TVA-SQN-TS-00-14

**SEQUOYAH NUCLEAR PLANT (SQN) -- UNITS 1 AND 2 -- TECHNICAL SPECIFICATION (TS) CHANGE NO. 00-14, SUPPLEMENTAL CHANGES (TAC NOS. MB6436 AND MB6437)**

UPDATED MARKUP PAGES  
FOR TECHNICAL SPECIFICATION (TS) CHANGE 00-14

FIGURE 3.4-2

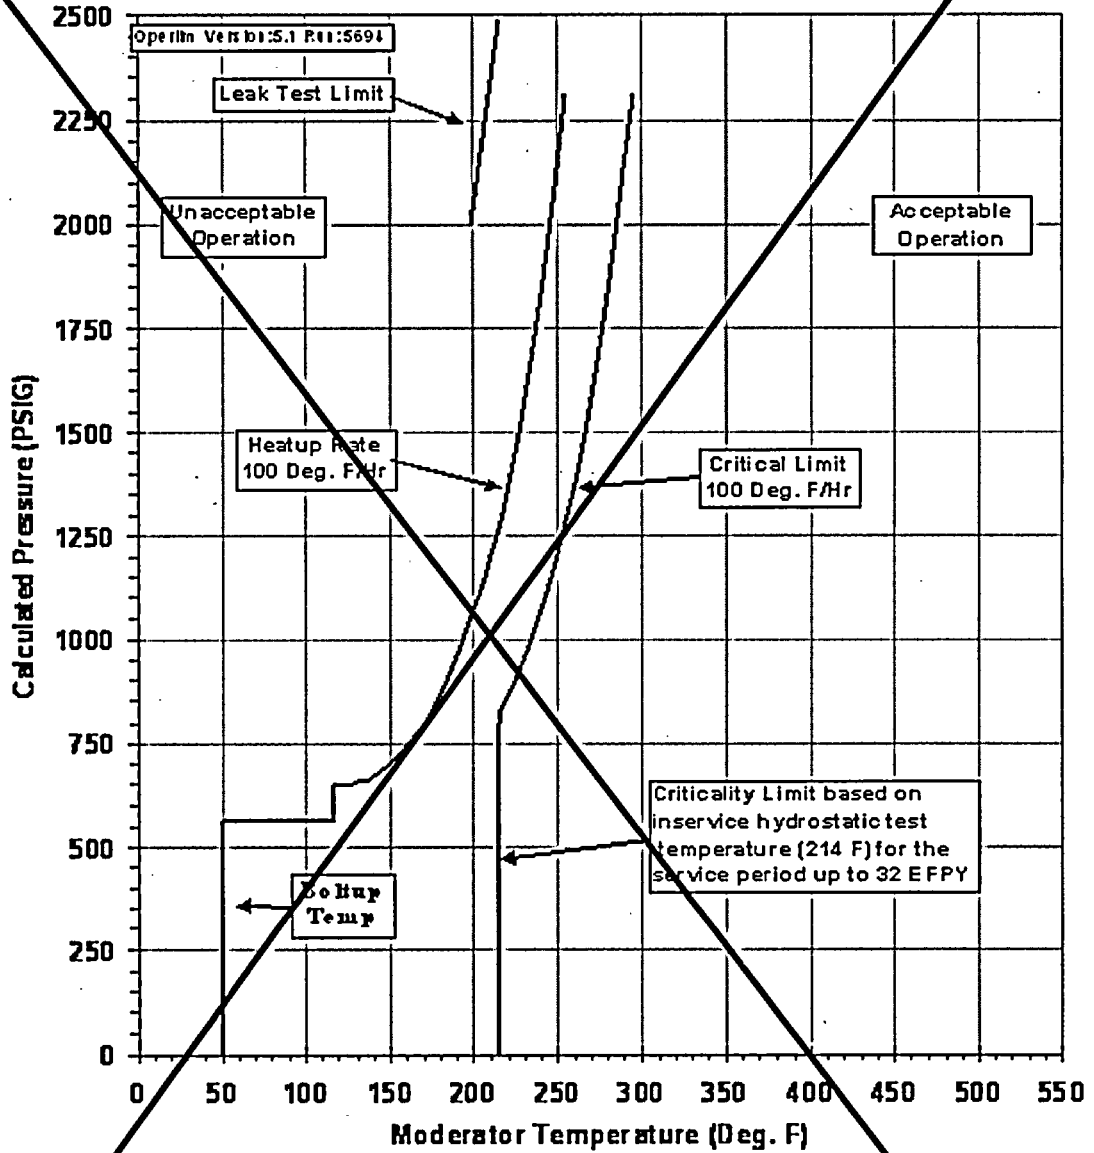
The first supplemental change provides for removal of the Unit 2 P-T limits that are currently contained in TS Figures 3.4-2 and 3.4-3. These P-T limits were incorporated into the SQN Unit 2 TSs under TS Change 03-08 for the purpose of replacing SQN's Unit 2 limits that expired July 2003. The TS Change 03-08 limits were developed with no exclusion for the flange region and were approved for use by NRC letter dated July 31, 2003. As discussed with the staff, these limits provide interim limits until the staff completes review of SQN's updated PTLRs (updated PTLRs are based on a site-specific exemption for exclusion of the flange region). Accordingly, the enclosed change removes the Unit 2 figures because these limits are superseded by the limits provided by the updated PTLRs.

DELETE FIGURE 3.4-2

FIGURE 3.4-3

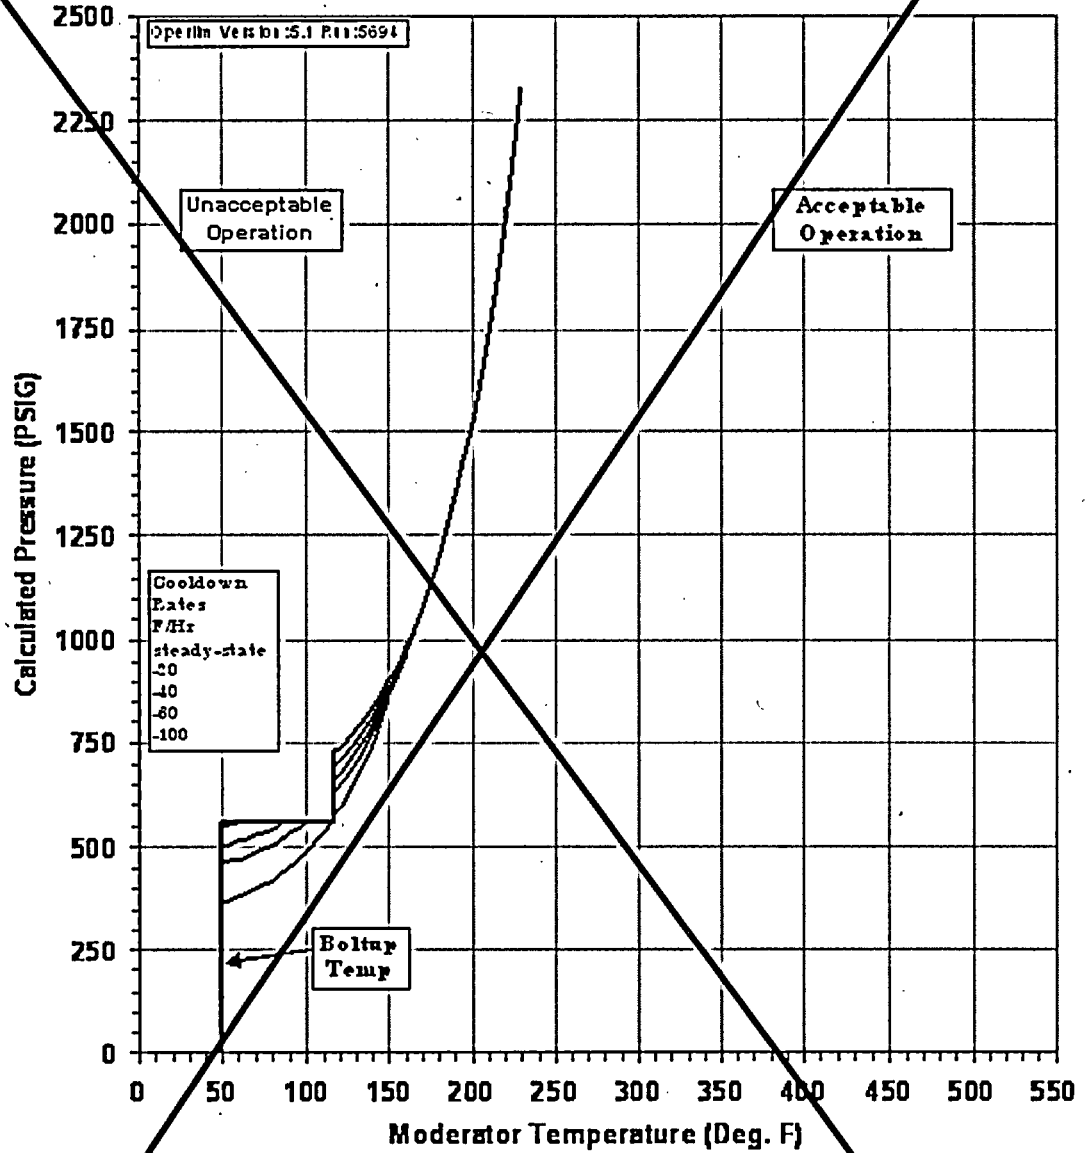
DELETE FIGURE 3.4-3
